STAFF REPORT: CITY OF TRINIDAD

APPLICATION NO: 2016-05

PROJECT LOCATION: 20 Scenic Drive

PROJECT DESCRIPTION: Grading Permit and Coastal Development Permit to replace a failed 24”/30” (inlet is 24 in. and outlet is 30 in.), approximately 180 ft. long corrugated metal culvert with a new 36 in., 180 ft. HDPE culvert in the same location along the base of Parker Creek. The culvert failed in January of 2016, and the new culvert is sized to accommodate 100 year storm flow.

SITE LAYOUT

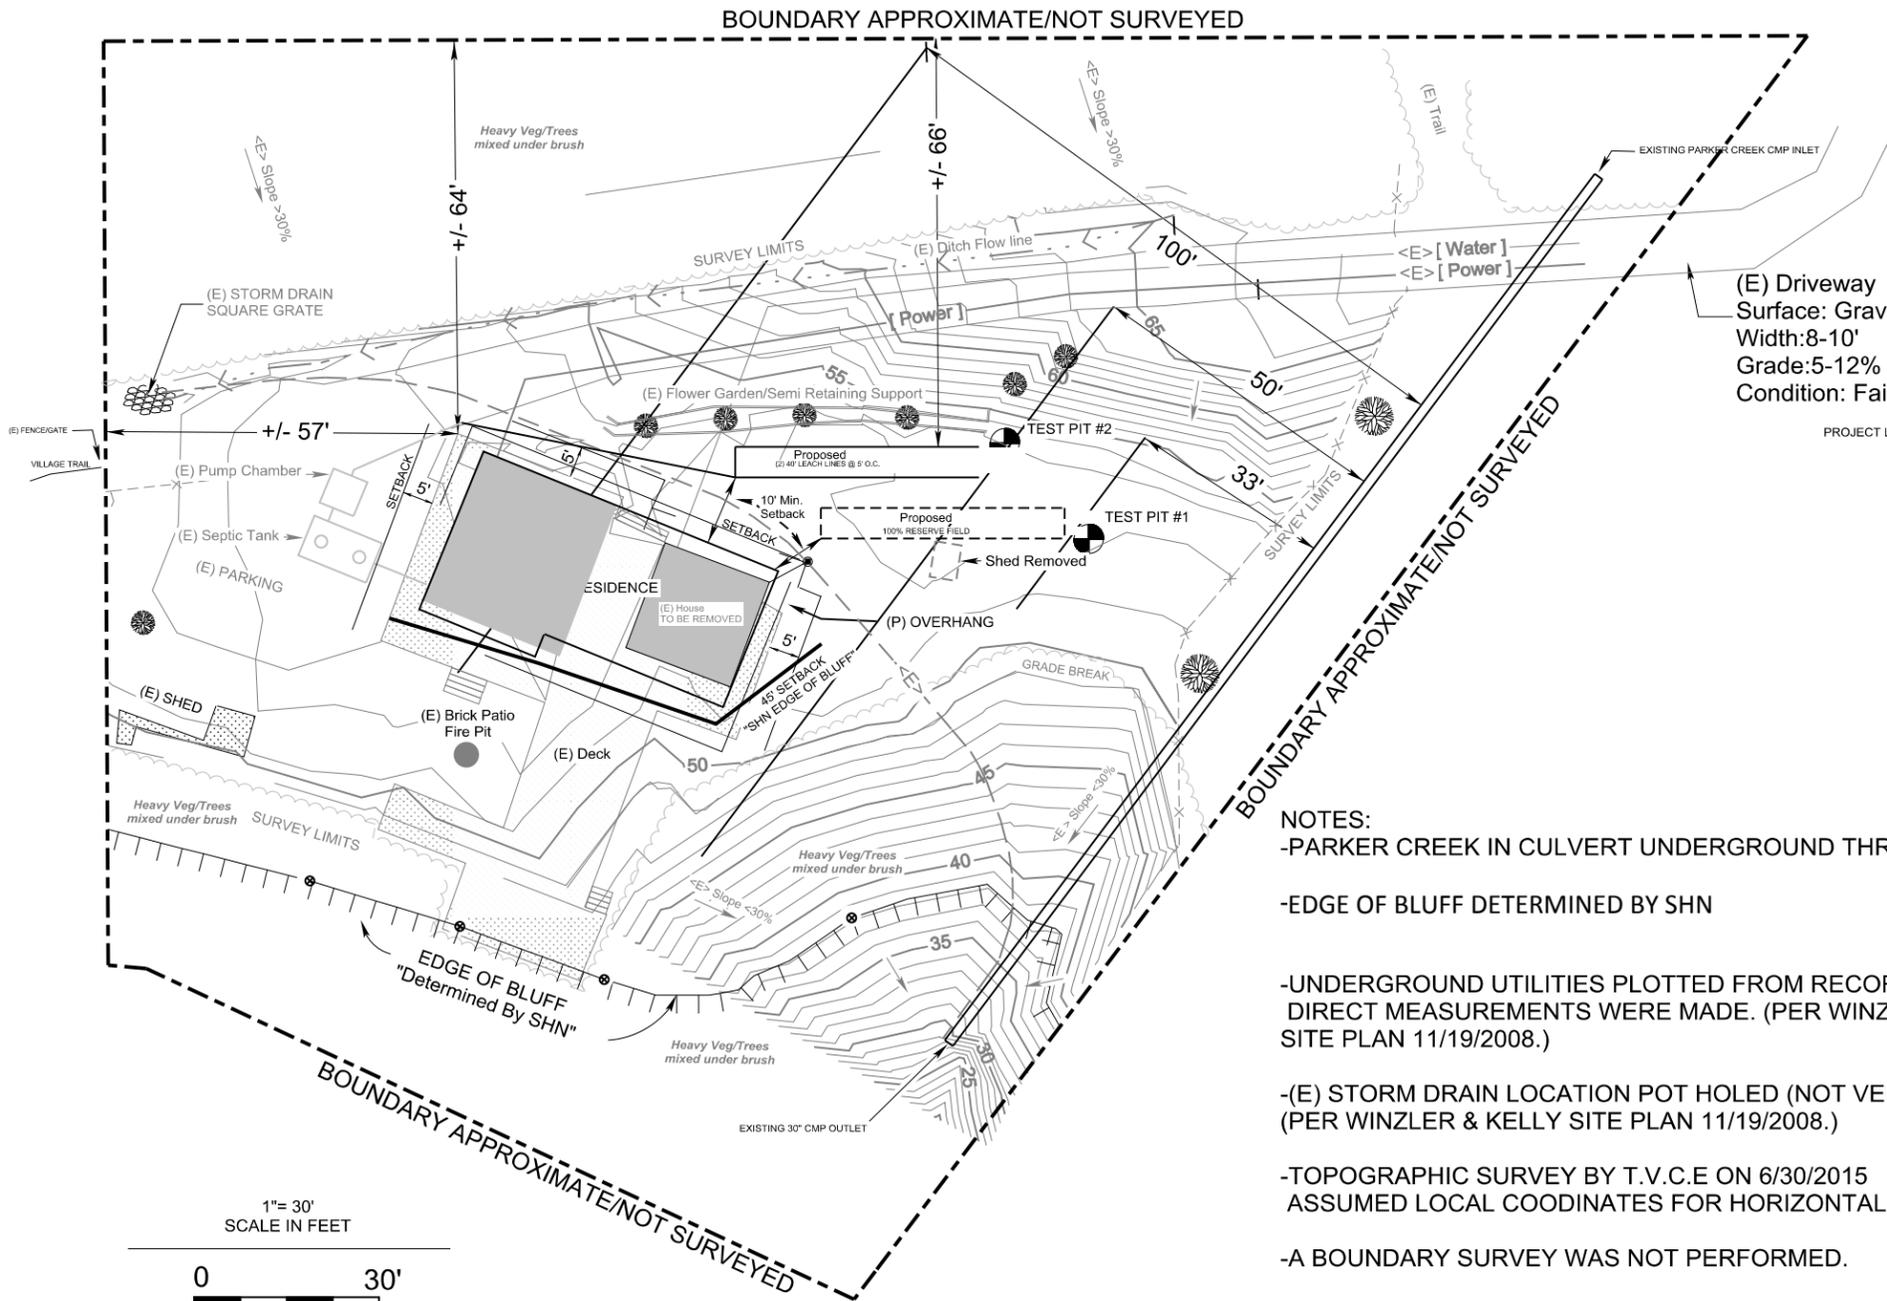
There is no sewage disposal system associated with this project. The culvert will not interfere with the existing leachfield or proposed repair (see site plan).

StreamStats Report

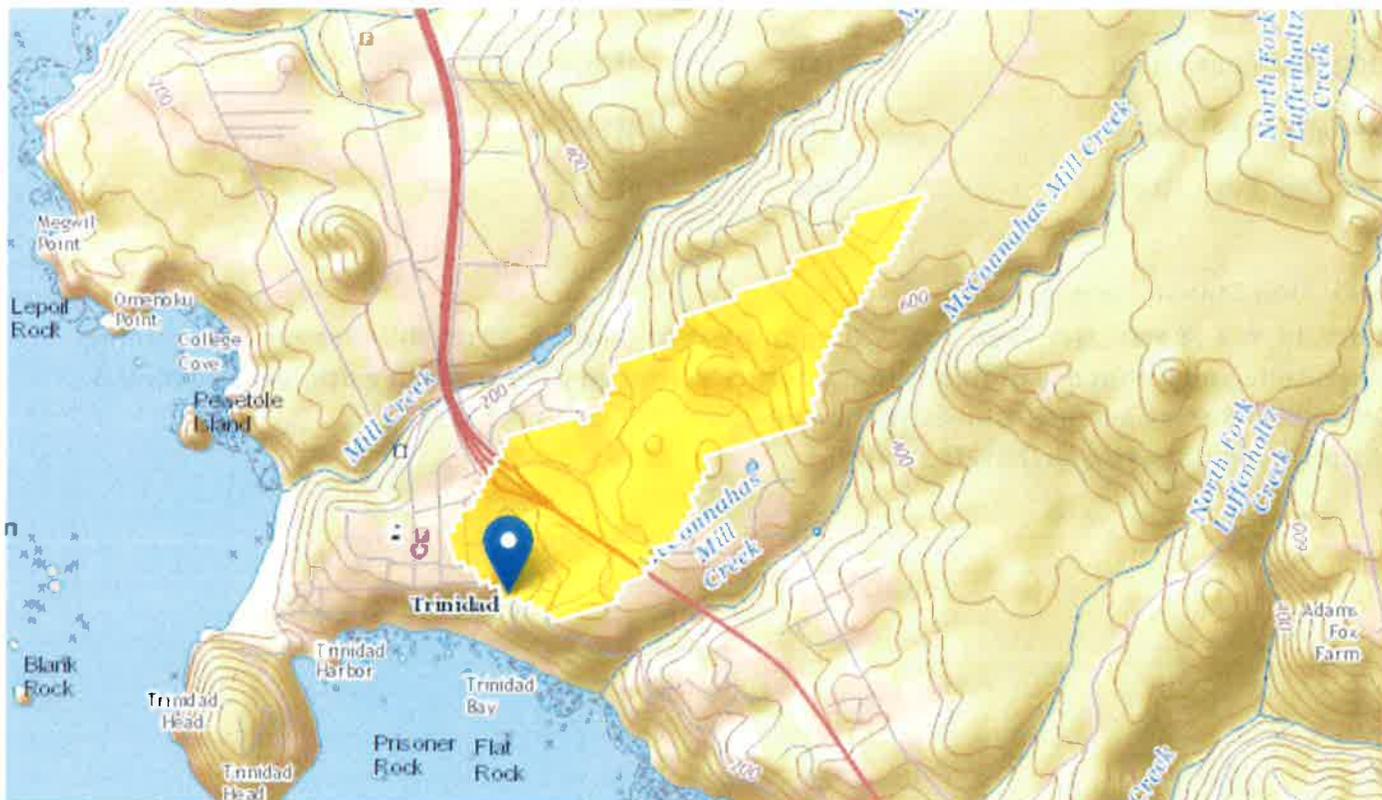
I ran the calculations this morning using the USGS streamstats program, see file attached. The second page shows the 100-year peak flow is estimated to be approximately 156 cfs.
